ADDENDUM NO. 2 TO BID NO. 16-0092-4

FOR: CHATHAM COUNTY DETENTION CENTER EXPANSION - PROJECT 2

**SECTION 00 9112**  
**ADDENDUM NUMBER 2**

**PROJECT: CHATHAM COUNTY DETENTION CENTER EXPANSION PROJECT 2**

**SD-A201**REFER TO DWG: **A2.101**

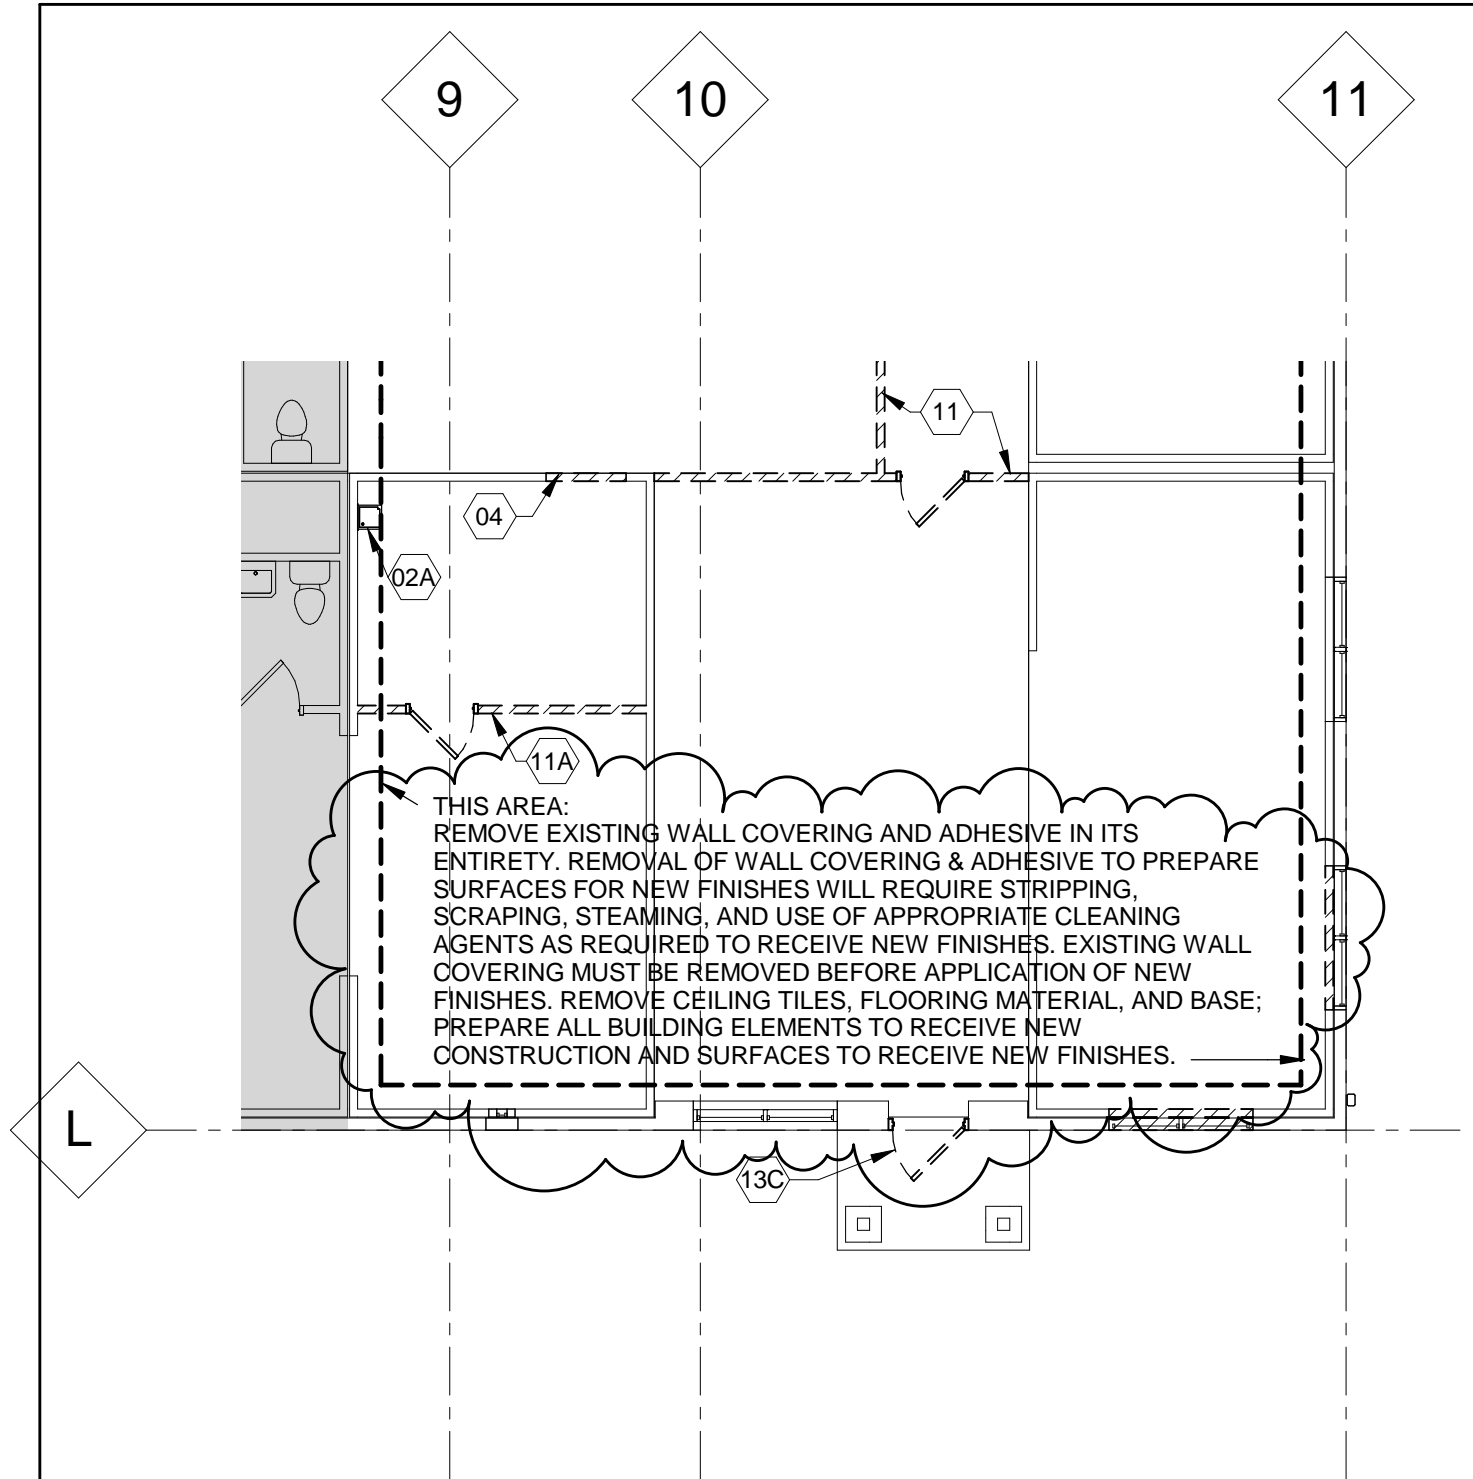
Item #07. Revise Drawing according to Supplemental Drawing SD-A201 issued with this addendum.

THIS AREA:  
REMOVE EXISTING WALL COVERING AND ADHESIVE  
IN ITS ENTIRETY. REMOVAL OF WALL COVERING &  
ADHESIVE TO PREPARE SURFACES FOR NEW FINISHES WILL  
REQUIRE STRIPPING, SCRAPING, STEAMING, AND USE OF  
APPROPRIATE CLEANING AGENTS AS REQUIRED TO RECEIVE NEW  
FINISHES. EXISTING WALL COVERING MUST BE REMOVED BEFORE  
APPLICATION OF NEW FINISHES. REMOVE CEILING TILES,  
FLOORING MATERIAL, AND BASE; PREPARE ALL BUILDING  
ELEMENTS TO RECEIVE NEW CONSTRUCTION AND SURFACES TO  
RECEIVE NEW FINISHES.

SUPPLEMENTAL DRAWING  
**SD-A202**  
REFER TO DWG: **A2.102**

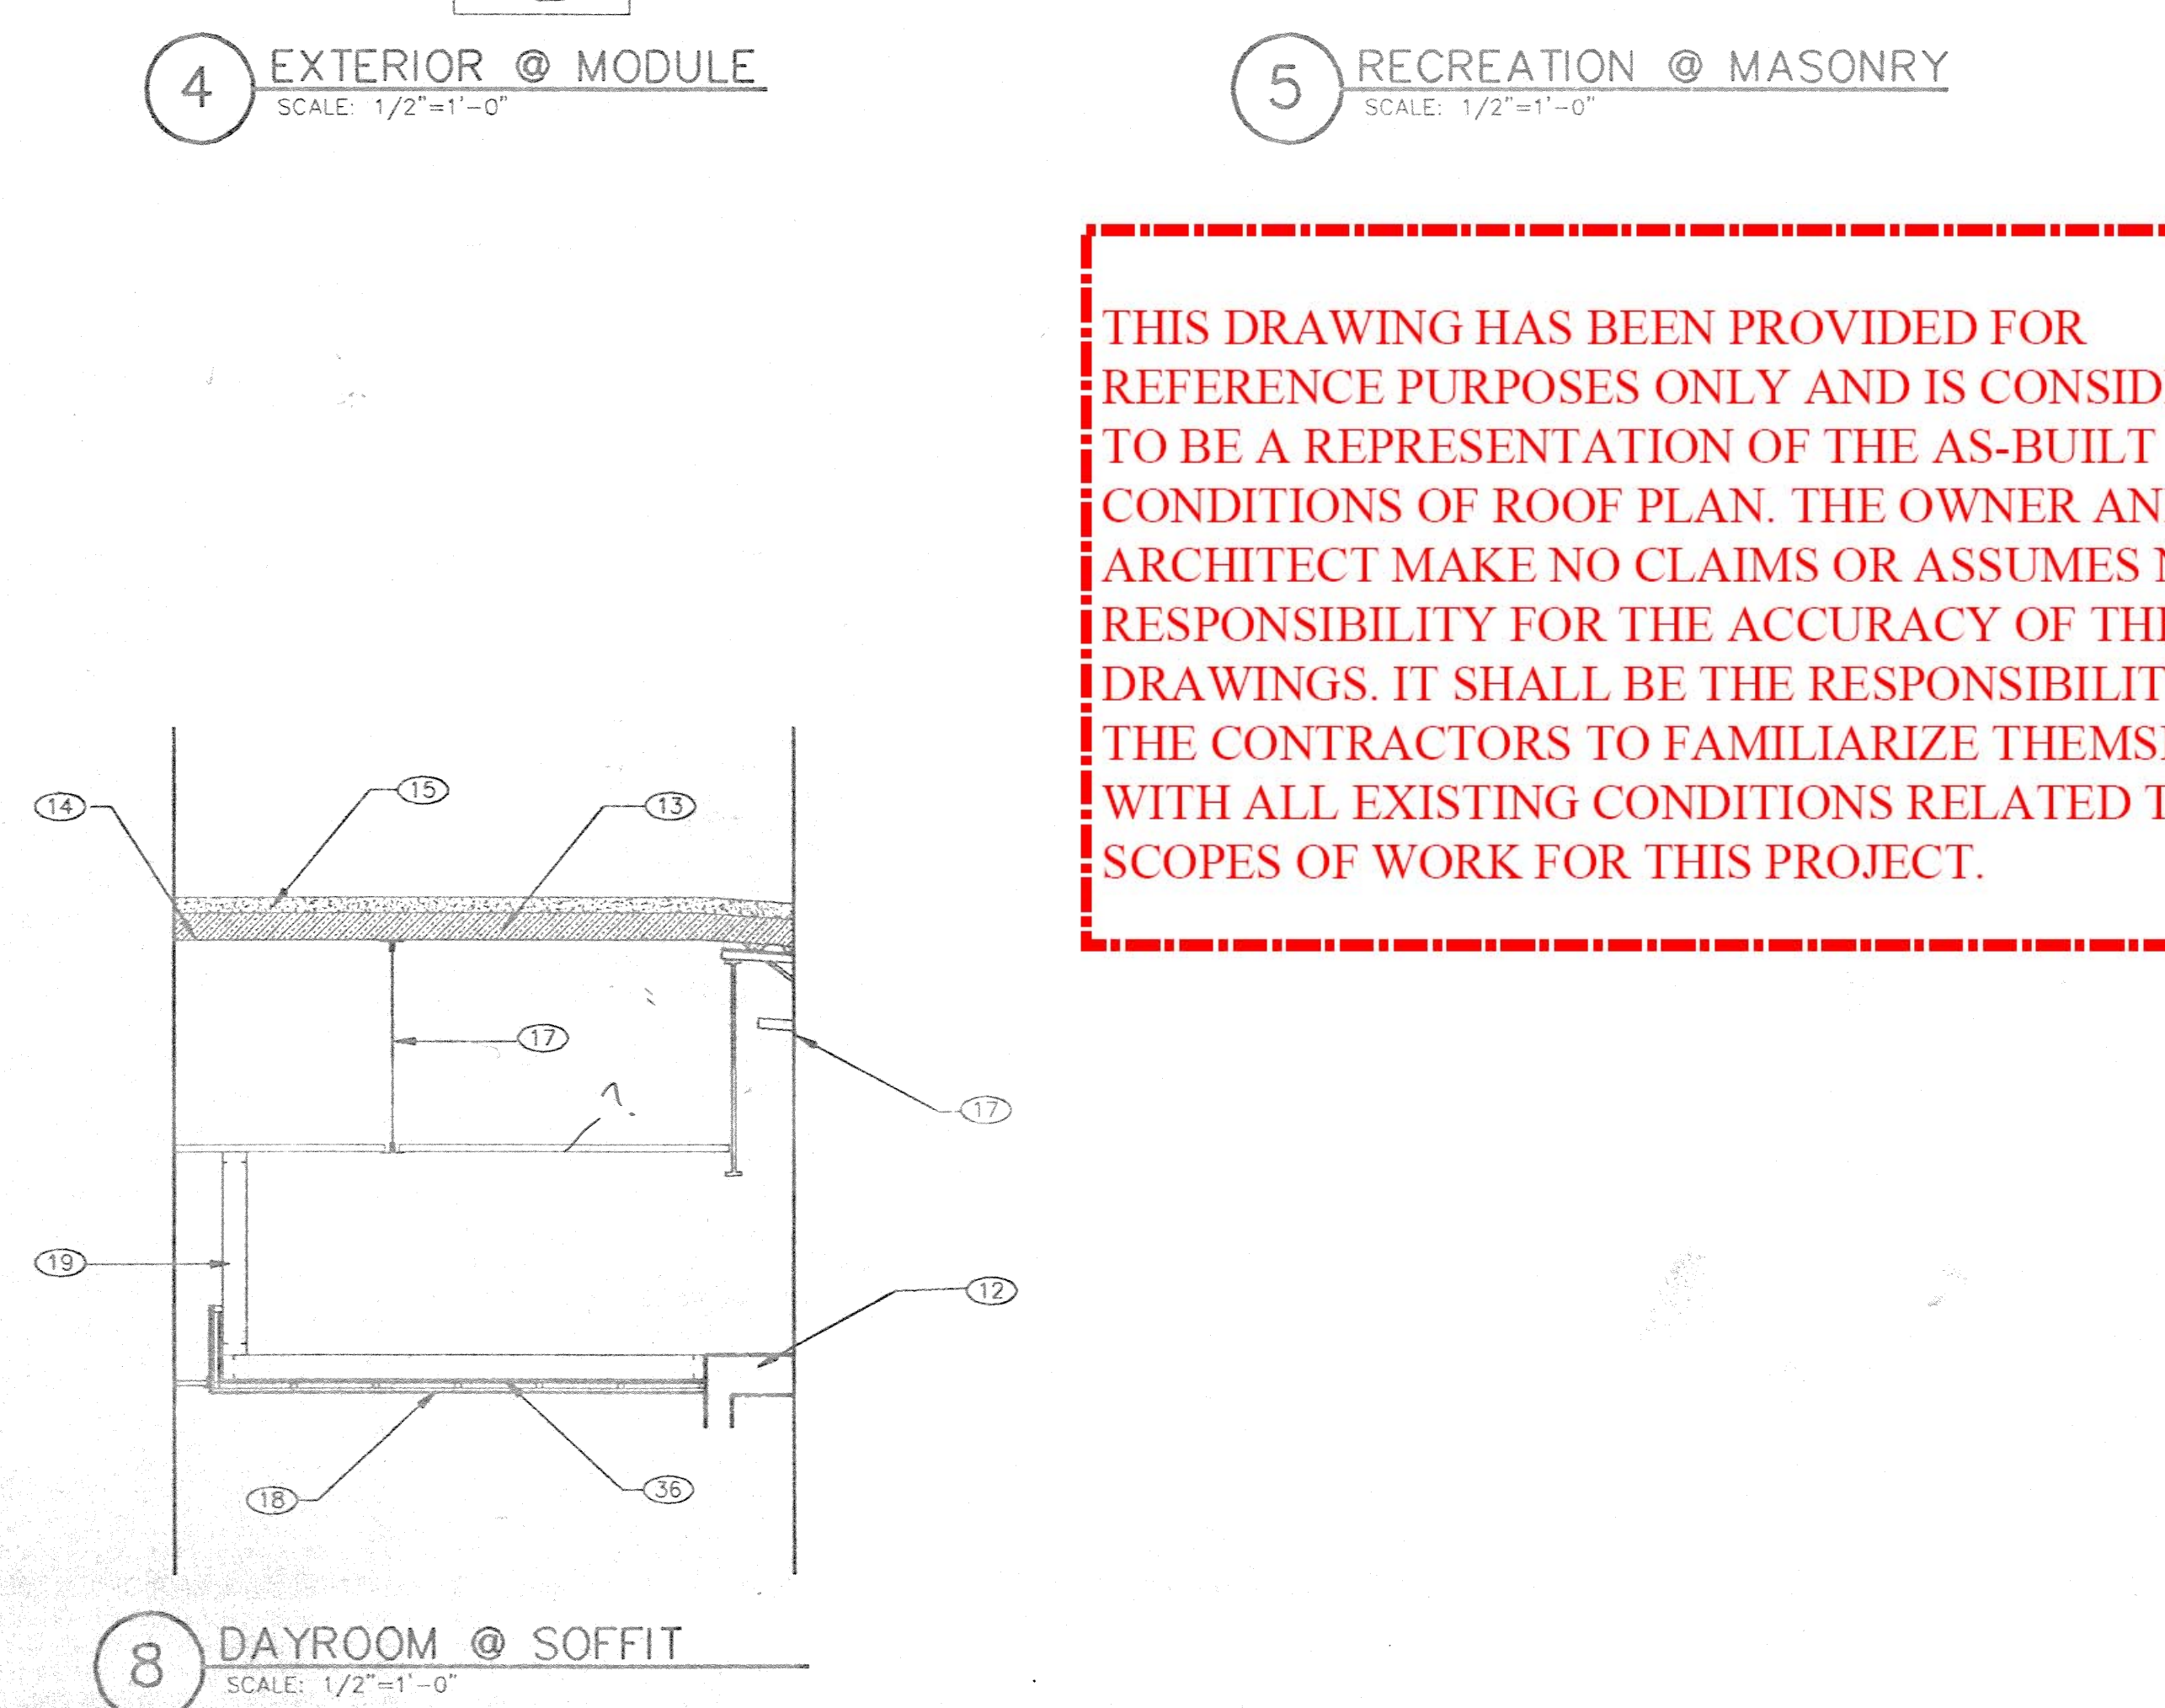
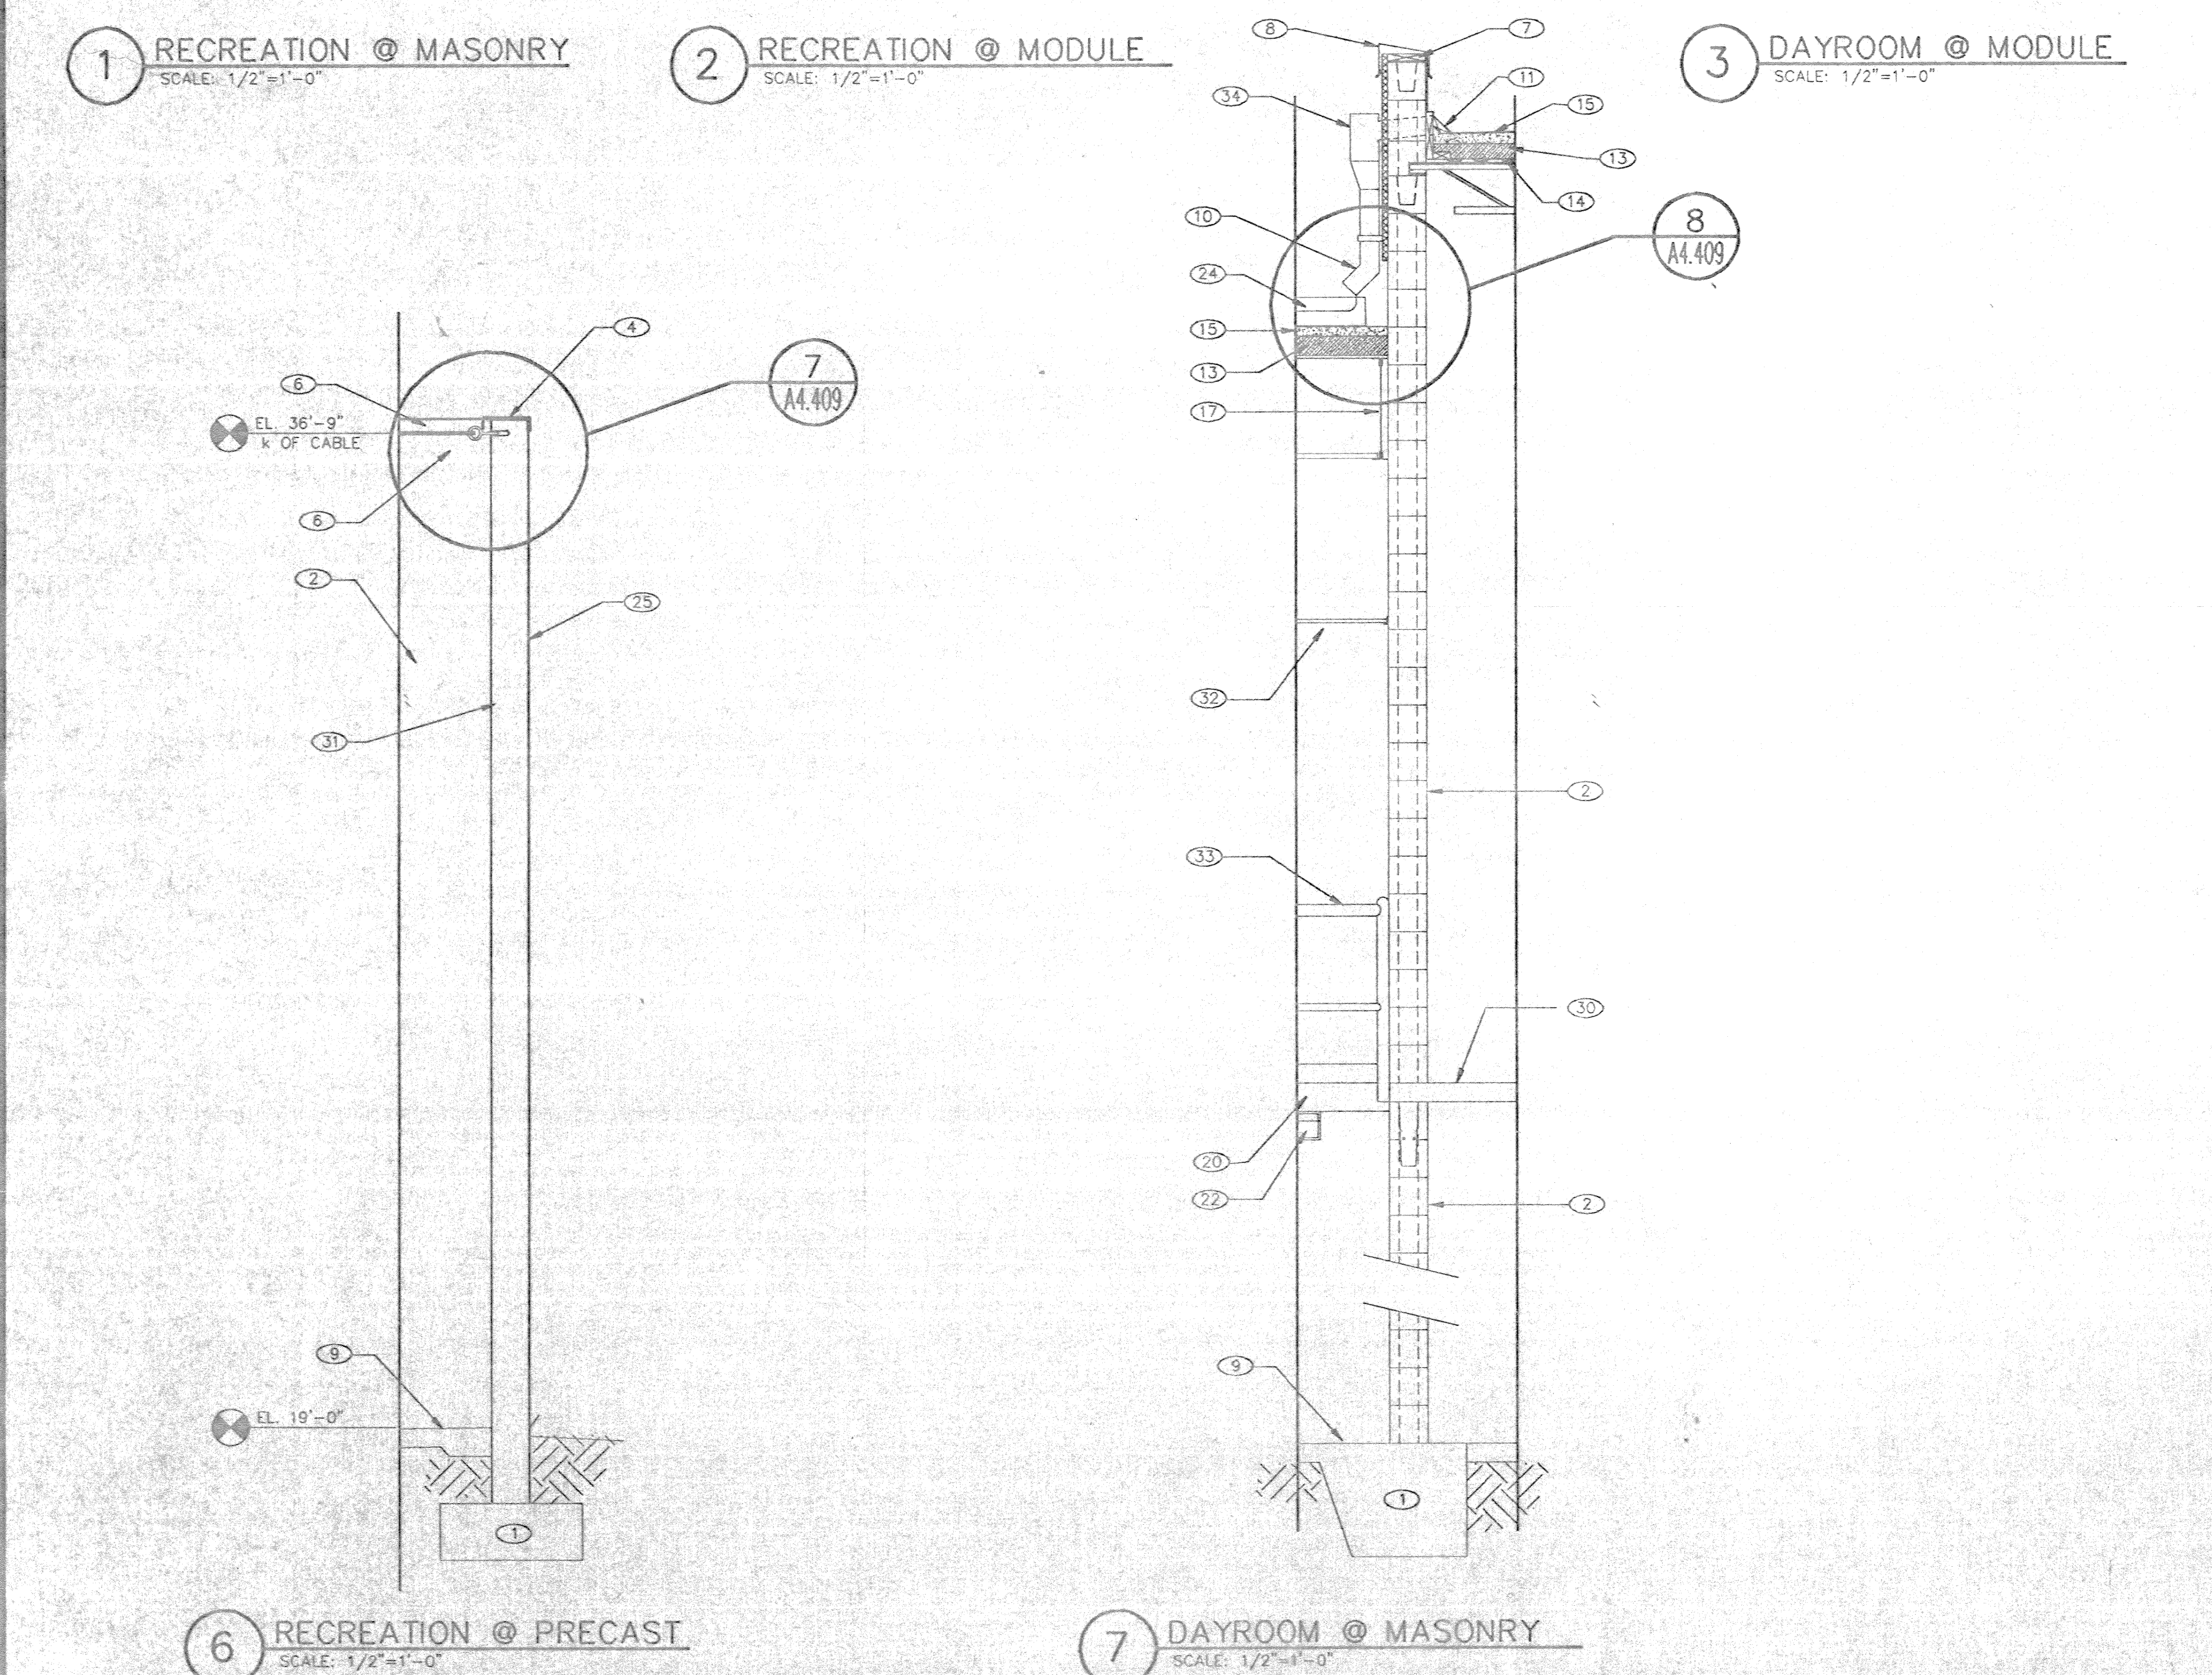
Item #08. Revise Drawing according to Supplemental Drawing SD-A202 issued with this addendum.
